DOCUMENT 00 91 13.01
ADDENDUM NO. 1

February 12, 2026

RE: Vernal City – 100 North Water and Sewer Line Replacement
Project No. 2506-057

FROM: Jones & DeMille Engineering, Inc.
205 North Vernal Avenue
Vernal, UT 84078

Trench Profile

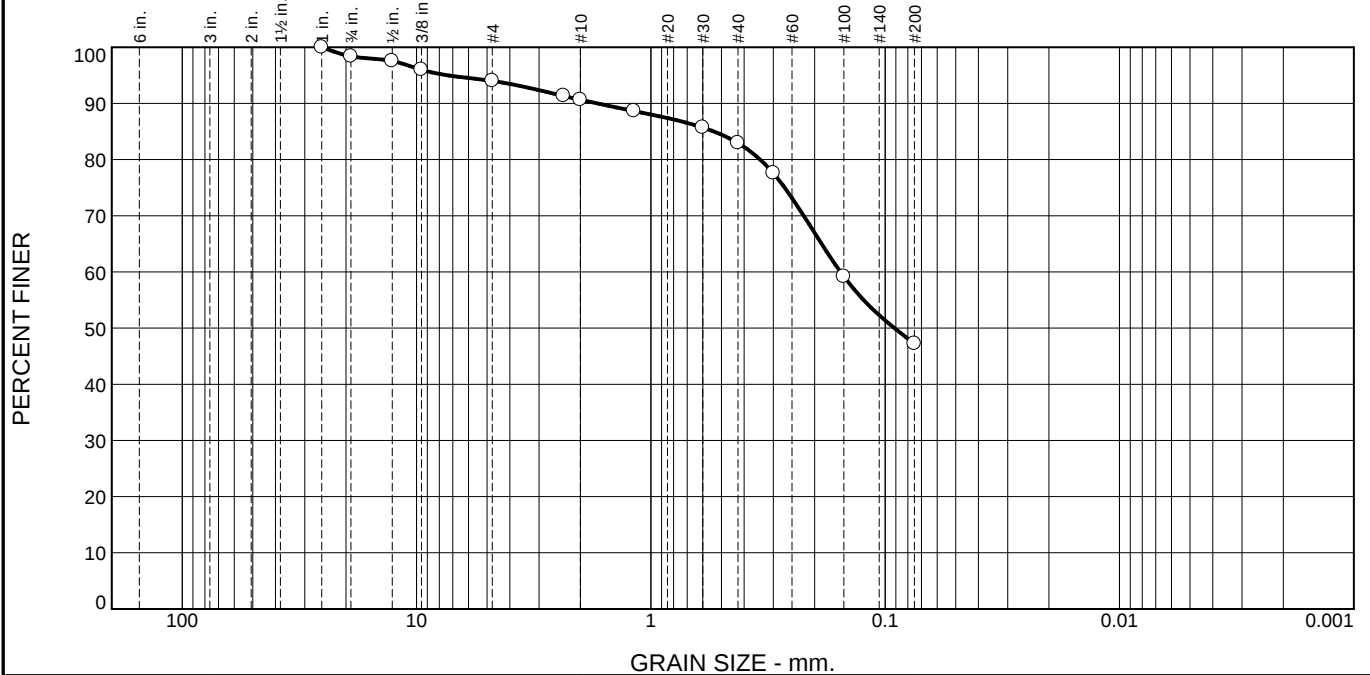
A: No official geotechnical report is available for this project. Soil samples were collected on 800 West and around 250 East 100 North. An exhibit providing a gradation and classification for these samples as well as images of trenches and native material is attached to this addendum.

Layer	Thickness	Notes
Asphalt Roadway Thickness:	5 in	HMA Asphalt
Road base	0 in	No road base was present at test hole location.
Native Soil	+ 48 in	See attached properties sheet for soil characteristics

Soil Samples were taken at a depth of 5 ft
